QUALITY ASSURANCE -- NON-CONFORMANCE REPORT

Report No: NCR-000896

NCR #: ZPMC-0858

Reference Description: Weld Procedure Requirements for New Welds Not Followed

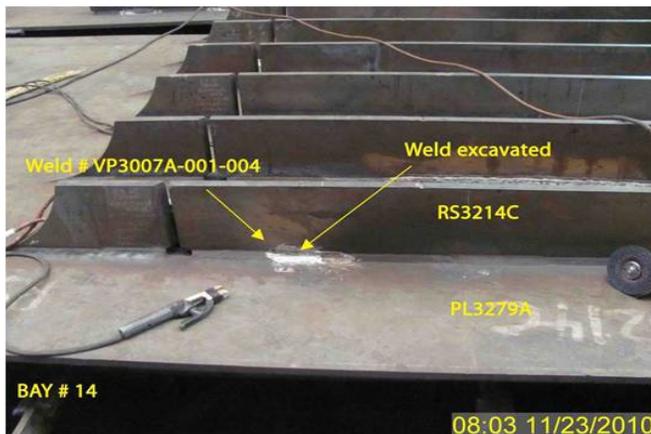
During the Quality Assurance (QA) random in-process observations of the fabrication of OBG in Bay #14, this Caltrans QA Inspector observed ZPMC welding personnel appear to not be following the following section of the New weld Procedure:

6. Non Destructive testing (6A)

- ZPMC personnel performed weld repair for the weld between "I" rib stiffener (RS3214C) and plate (PL3279A) without performing NDT (Magnetic Particle testing) on the excavated area.
- Weld number identified as VP3007A-001-004
- Weld details as complete joint penetration(CJP) , Fracture critical weld (FCW)
- PL3279A designated on the approved shop drawings as Seismic Performance Critical Members (SPCM).
- The welding performed with Shielded Metal Arc Welding (SMAW) process.

See attached photographs for additional detail.

The "NEW WELD PROCEDURE (Rager/McQuaid)" quoted as the basis for this NCR is not a contract document only a recommendation from the QA/QC Committee. If the Department wants to incorporate the QA/QC committee's recommendations as a contract requirement a contract change order should be issued. As this NCR was written without basis it should be withdrawn.

CT acknowledges contractor's response. However, successful NDT will close this NCR.

Normal NCR closure package with NDT reports shall be submitted with the NPR to close out the NCR.

See attached NDT results to show the weld is acceptable. Based on this ZPMC requests closure of this NCR.

This proposed resolution is acceptable. The documentation received is sufficient and the Department concurs that Non-Conformance ZPMC-0858 is closed.

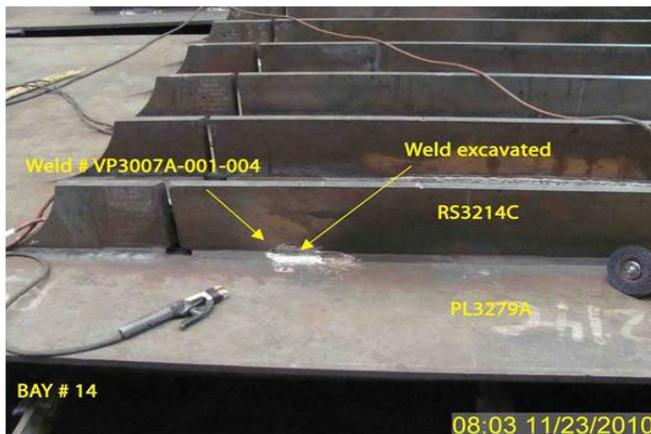
During the Quality Assurance (QA) random in-process observations of the fabrication of OBG in Bay #14, this Caltrans QA Inspector observed ZPMC welding personnel appear to not be following the following section of the New weld Procedure:

6. Non Destructive testing (6A)

- ZPMC personnel performed weld repair for the weld between "I" rib stiffener (RS3214C) and plate (PL3279A) without performing NDT (Magnetic Particle testing) on the excavated area.
- Weld number identified as VP3007A-001-004
- Weld details as complete joint penetration(CJP) , Fracture critical weld (FCW)
- PL3279A designated on the approved shop drawings as Seismic Performance Critical Members (SPCM).
- The welding performed with Shielded Metal Arc Welding (SMAW) process.

See attached photographs for additional detail.
